Application of Architectural Standard, LLC c/o Battle Law, P.C. for a major modification of zoning conditions pursuant to CZ-17-21564 for a mixed-use development in the MU-4 (Mixed-Use High Density) zoning district and Tier 2 of the I-20 Overlay District, at 4015 Flat Shoals Parkway.

PETITION NO: D1-2024-1496 CZ-25-1246771

LOCATION: 4015 Flat Shoals Parkway, Decatur, Georgia 30034

STAFF ANALYSIS

DRI SITE PLAN

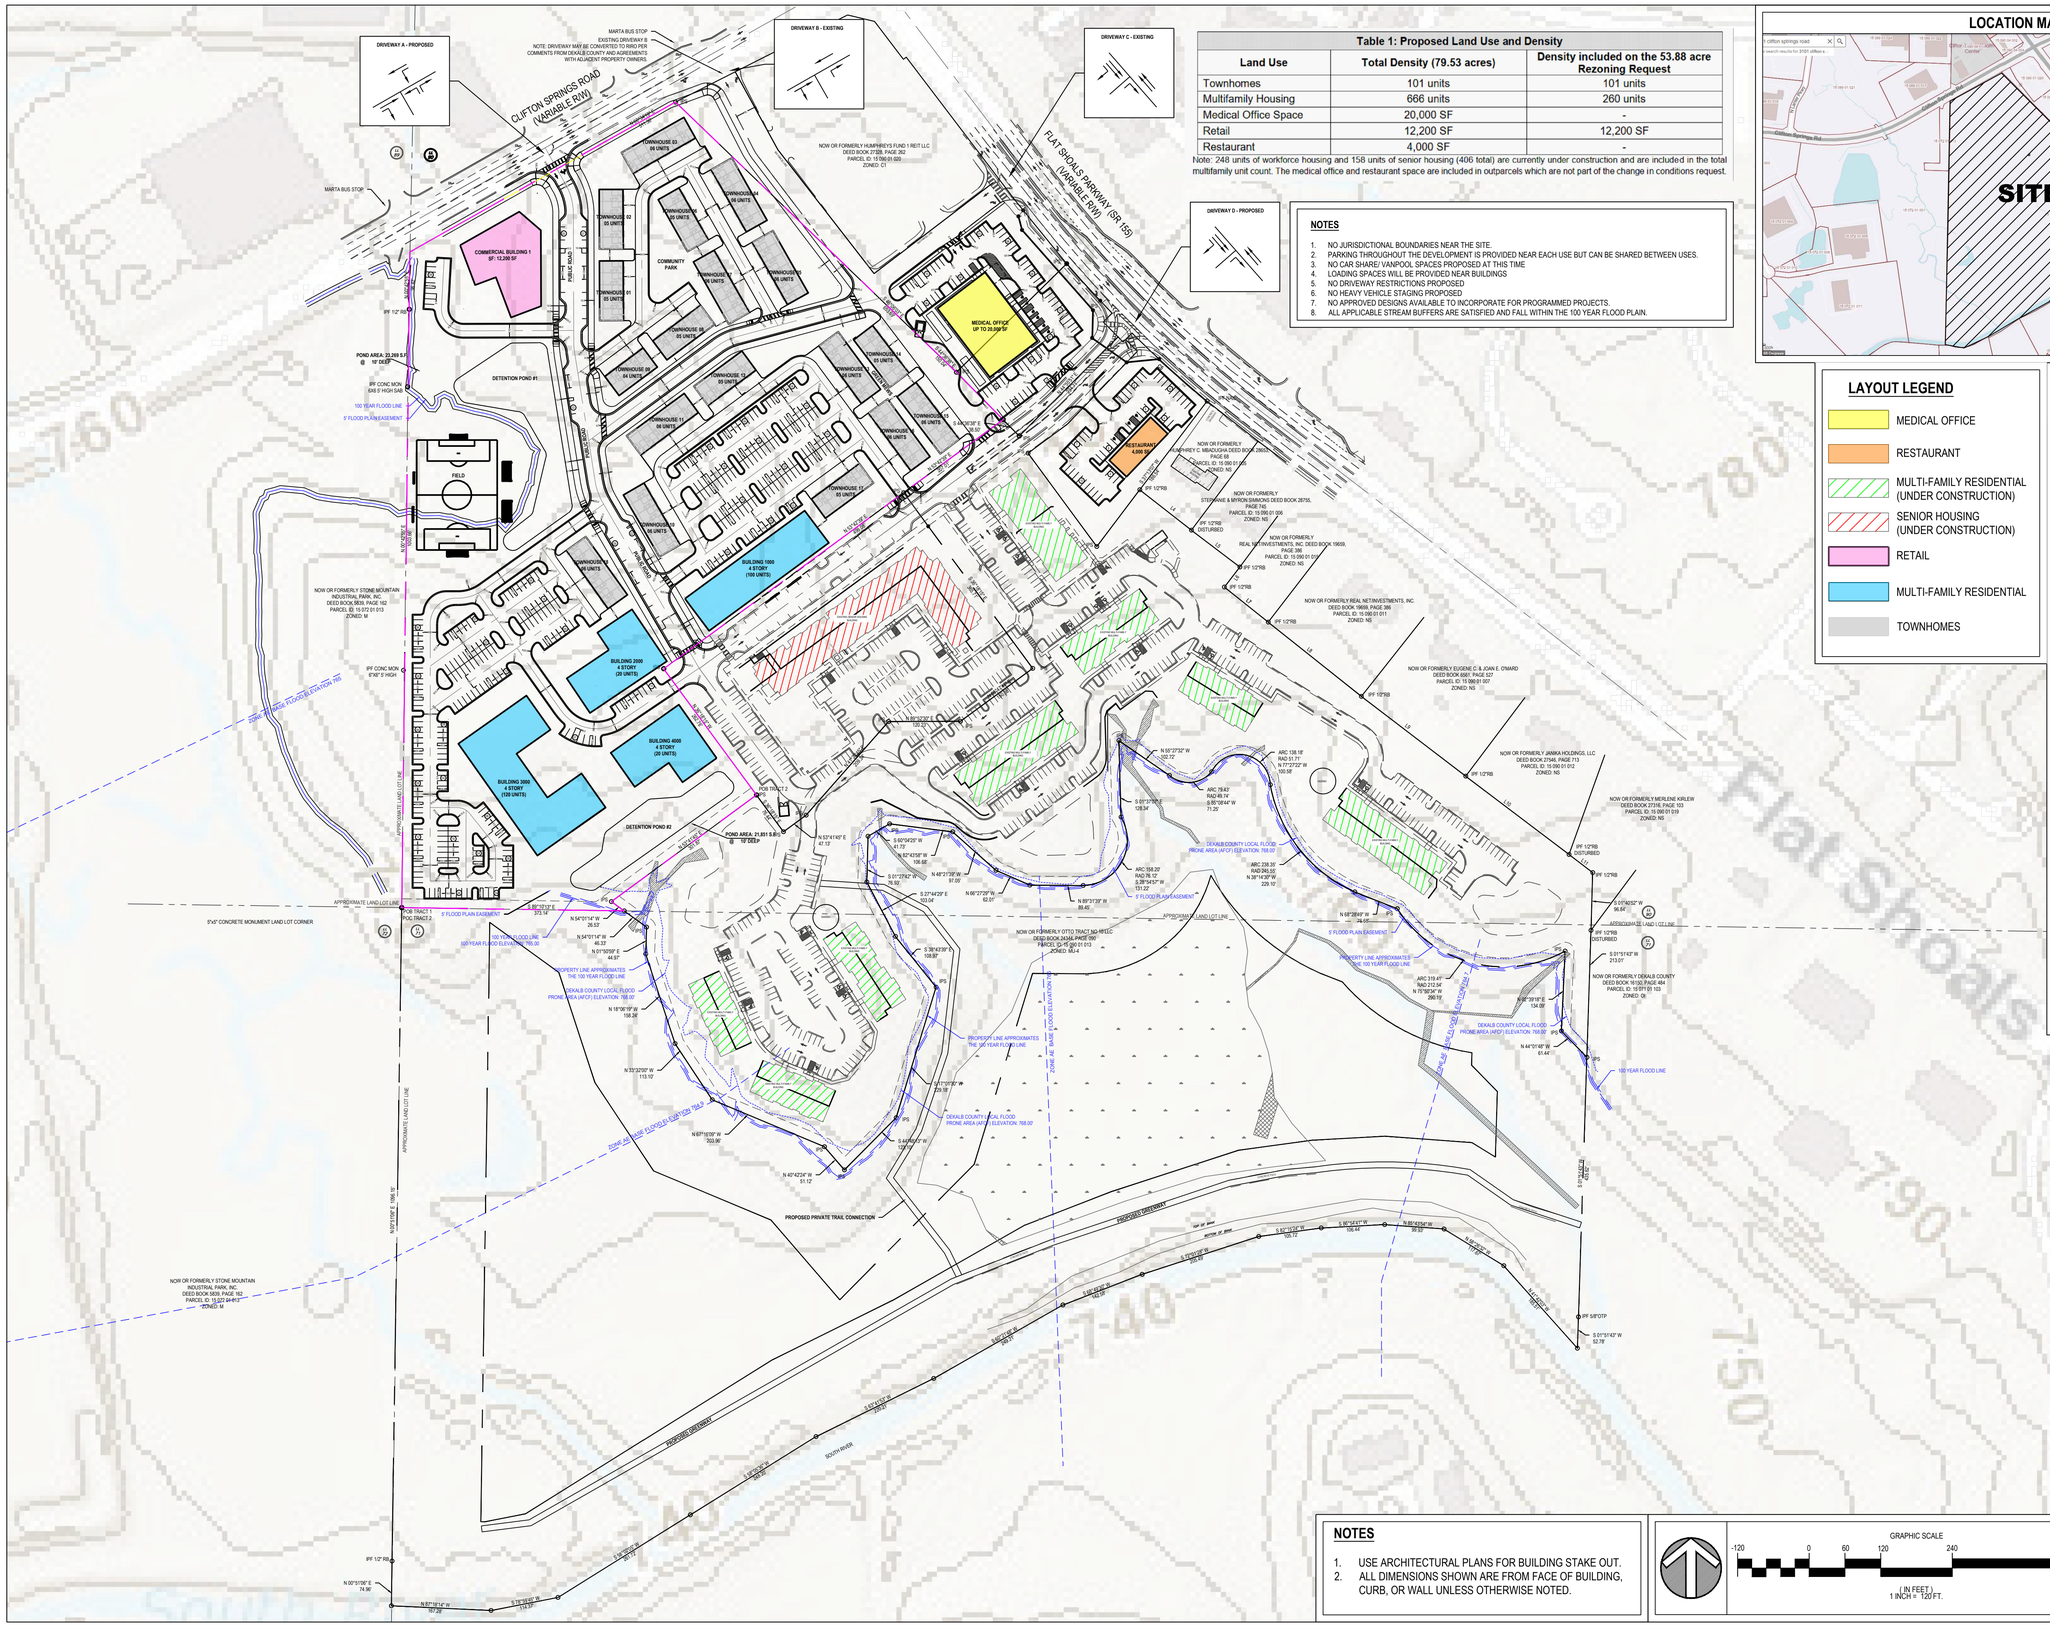
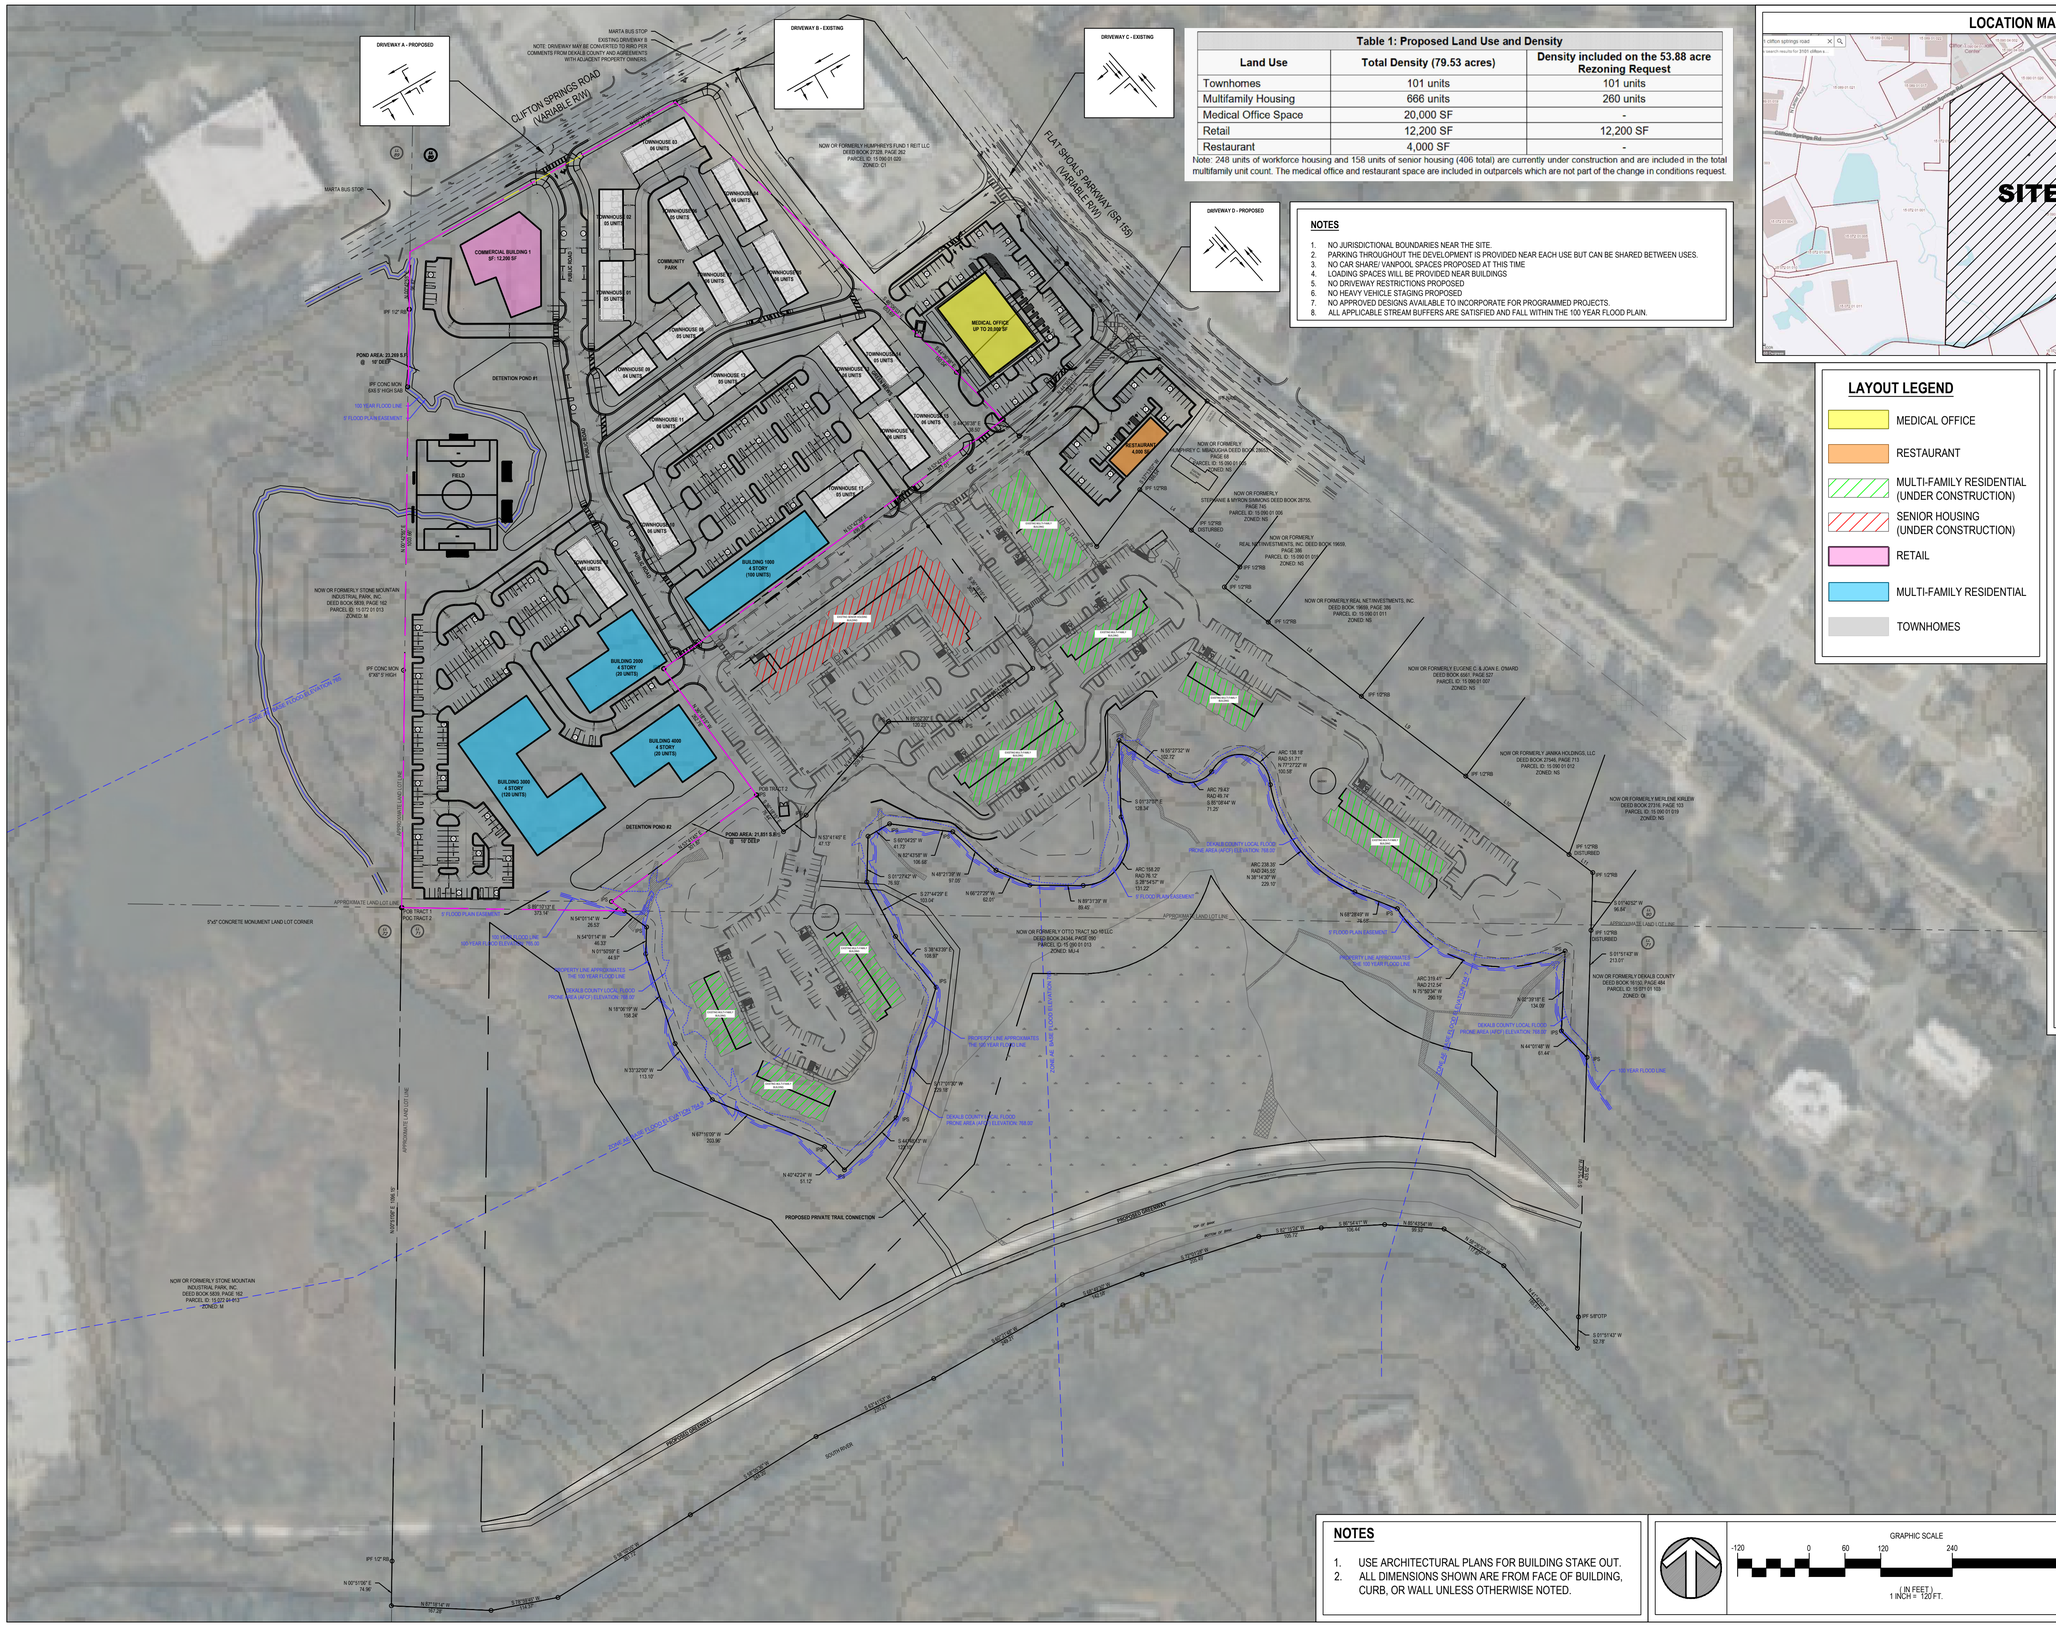
Care should be taken in creating the final plan to utilize basic urban design principles that enhance placemaking and support pedestrian activity. The office and restaurant footprints proposed at the driveway D entrance are set back from both the new main entrance street and Flat Shoals Parkway. Both buildings should be placed along with the driveway frontage at a minimum and possibly closer to Flat Shoals Parkway to create an inviting entrance for those arriving by foot or by car which would attract additional customers to the project retail elements. The placement along the street edge of the new central roadway with parking on the sides or the rear will create a sense of place and encourage pedestrian access. The placement of these buildings as shown in the current plan only perpetuates widely acknowledged urban planning failures of the 1970's and 80's. Many jurisdictions are struggling to retrofit solely vehicularly oriented suburban development patterns like this and constructing new ones is inconsistent with multiple regional development policies.

While sidewalks are generally provided in some areas of the project, their placement and width is unclear from the plans. Further, there are some key blocks where no sidewalks are provided which is in direct oppostion to the need to provide pedestrian access to destinations both within the project and within a walkable distance. In particular, pedestrian access from various points within the project to the Quick Trip convenience store just a block or two away is limited or even non-existent which is in direct opposition to regional multi-modal transportation and walkable neighborhood policies.

The South River forms the southern boundary of the project property, as shown on the project site plan. Both the USGS coverage for the project area and the submitted site plan show one blue-line stream crossing the southwestern corner of the property. Neither the 25-foot State Sediment and Erosion buffer nor the County 75-foot stream buffer are shown along the stream or along the South River. While none of the proposed development is shown near either the stream or the South River, the buffers should be shown to indicate their presence for project revisions or future development.

The project proposes to retain approximately 31 acres of the approximately 80 total acres as open/undisturbed space which is supportive of regional environmental policies.
Additional retention of wooded and stream adjacent areas would be desirable and in keeping with regional goals regarding carbon sequestration and climate change/heat island effect mitigation. There may be potential opportunities for linking these fragmented undeveloped areas with adjacent undeveloped or protected areas to ensure their maintenance and potential use for recreation or habitat preservation. Incorporation of green stormwater and heat island mitigation designs for the extensive surface car parking spaces proposed and use of an ecosystem-based design for the stormwater detention areas would be supportive of regional environmental policies.
